TO: Members of the MAG Specifications and Details Committee

SUBJECT: <u>MEETING NOTIFICATION AND TRANSMITTAL OF AGENDA</u>

MEETING MINUTES FROM THE MARICOPA ASSOCIATION OF GOVERNMENTS STANDARD SPECIFICATIONS AND DETAILS COMMITTEE

3. 2006 Cases

TYPE 'A' - SEWER BUILDING CONNECTION ELECTRONIC BALL MARKERS (STANDARD)

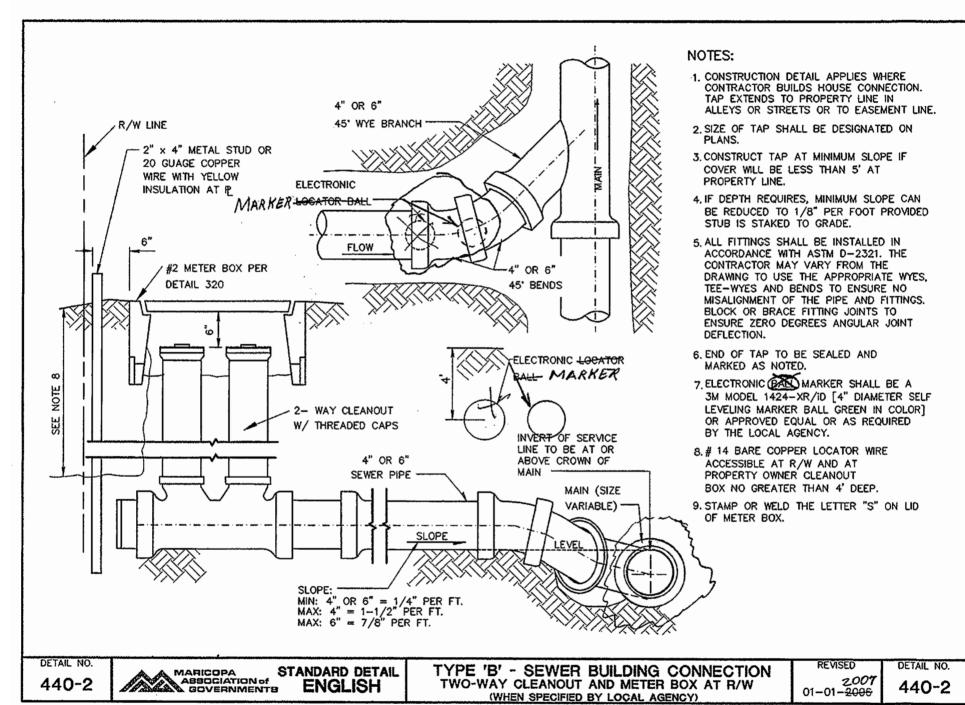
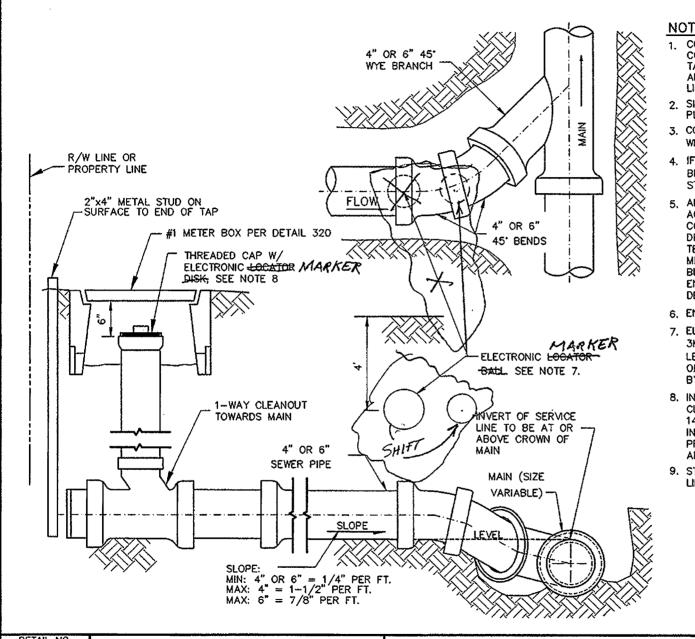
- b. Case 06-02 Clarifications to Detail 440: Revisions to Detail 440-1, 440-2 and 440-3. The committee had no discussion on this item and members were requested to be prepared to vote on this case at the next meeting.

| CASE | DESCRIPTION | PROPOSED BY | MEMBER | SUBMITTAL DATE Last Revision | VOTE DATE | VOTE |
|-------|--|----------------|---------|--|-----------|----------------------|
| 06-02 | Corrections to Detail 440, Revisions to section 615.6.2 and 615.7. | MCDOT | Herz | 2/01/2006 440-1 Rev. 3/01/2006 Specs 4/05/2006 | | Yes No Abstain |

FRAME AND GRATE FOR TYPE 'D' CATCH BASIN

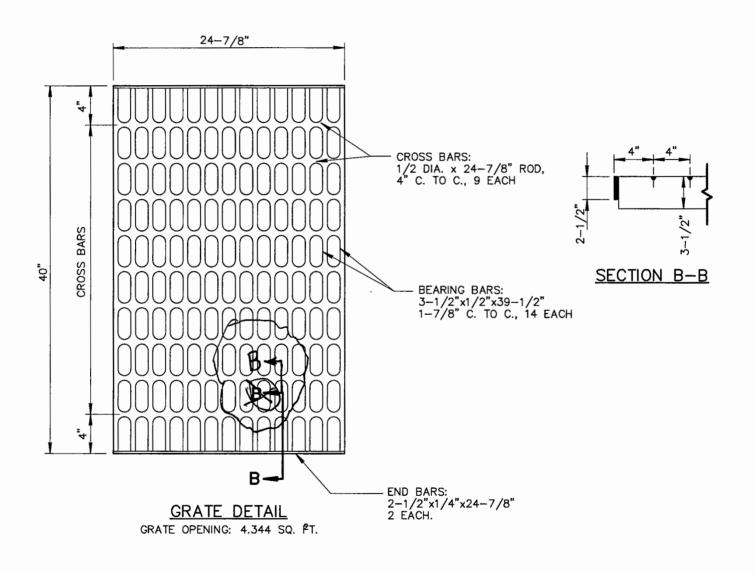
- c. Case 06-03 Miscellaneous Corrections: Drafting correction to Details 533-3 and 533-4. The committee had no discussion on this item and members were requested to be prepared to vote on this case at the next meeting.

| CASE | DESCRIPTION | PROPOSED BY | MEMBER | SUBMITTAL DATE Last Revision | VOTE DATE | VOTE |
|-------|--|----------------|---------|--|-----------|----------------------|
| 06-03 | Miscellaneous Bloopers Case A – Correct Section reference arrows on detail sheets 533-3 and 533-4. | MCDOT | Herz | 2/01/2006 2/01/2006 | | Yes No Abstain |

CURB AND GUTTER TYPES A, B, C AND D REVISED

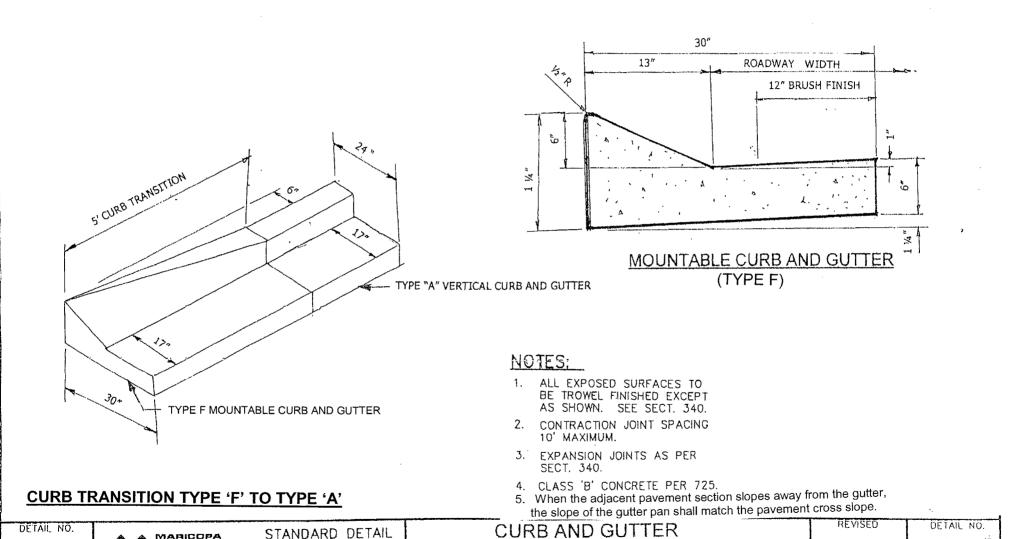
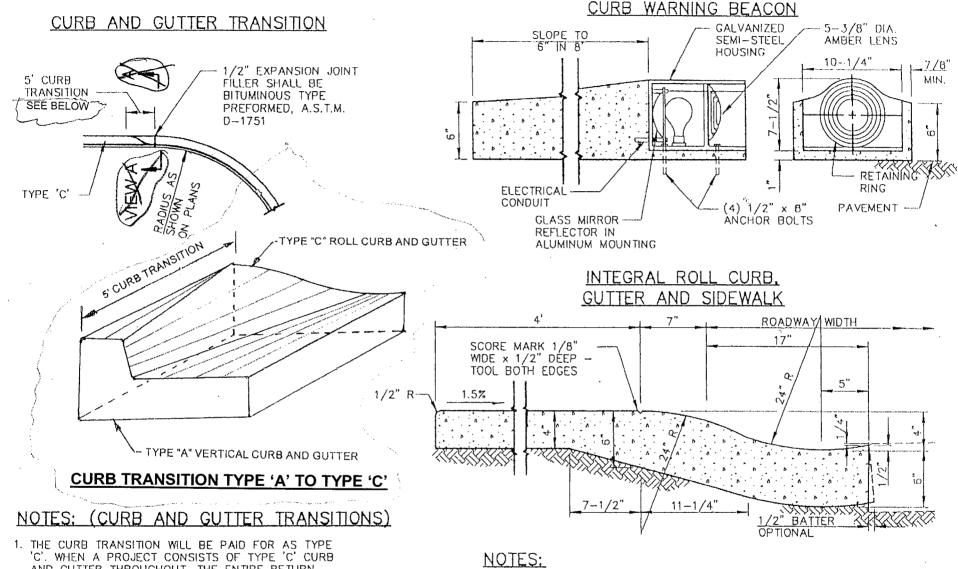
- g. Case 06-07 Add 24-inch wide Mountable Curb & Gutter with Transition View to Detail 220. Bob Herz proposed renumbering the existing Detail 220 to Detail 220-1 and have the proposed new detail numbered as Detail 220-2. Revise the proposed Mountable Curb & Gutter section to add Roadway Width dimensioning limits as is shown on other existing curb and gutter cross sections, delete the Class "B" Concrete callout since this is identified in Note 4, and identifying the cross section with a description similar to the other cross sections in 220 (title as "Type E" instead of "M-24"). The title Mountable Curb to Vertical Curb Transition be revised to Curb Transition Type E to Type A to not duplicate the title used in Case 06-08. After discussion, the committee also recommended that this cross section and the one proposed for Case 06-08 be combined into a single new detail page with the title revised to be consistent with the title on the existing Detail 220. Members were requested to be prepared to vote on this case (as modified during the discussion) at the next meeting.

- h. Case 06-08 Add 30-inch wide Mountable Curb & Gutter with Transition View to Detail 220. Bob Herz proposed renumbering the existing Detail 220 to Detail 220-1 to be consistent with this proposed detail 220-2. Revise the cross section description to be similar to the other cross sections in 220 (title as "Type F" instead of "M-30"). The title Mountable Curb to Vertical Curb Transition be revised to Curb Transition Type F to Type A to not duplicate the title used in Case 06-07. Members were requested to be prepared to vote on this case (as modified during the discussion) at the next meeting.

| CASE | DESCRIPTION | PROPOSED BY | MEMBER | SUBMITTAL DATE Last Revision | VOTE DATE | VOTE |
|-------|--|----------------|---------|--|-----------|----------------------|
| 06-07 | Detail 220 Add Mountable Curb & Gutter (Type M-24) and transition detail. | Scottsdale | Ramos | 7/5/2006 8/2/2006 | | Yes No Abstain |
| 06-08 | Detail 220 Add Mountable Curb & Gutter (Type M-30) and transition detail. | Scottsdale | Ramos | 7/5/2006 8/2/2006 | | Yes No Abstain |
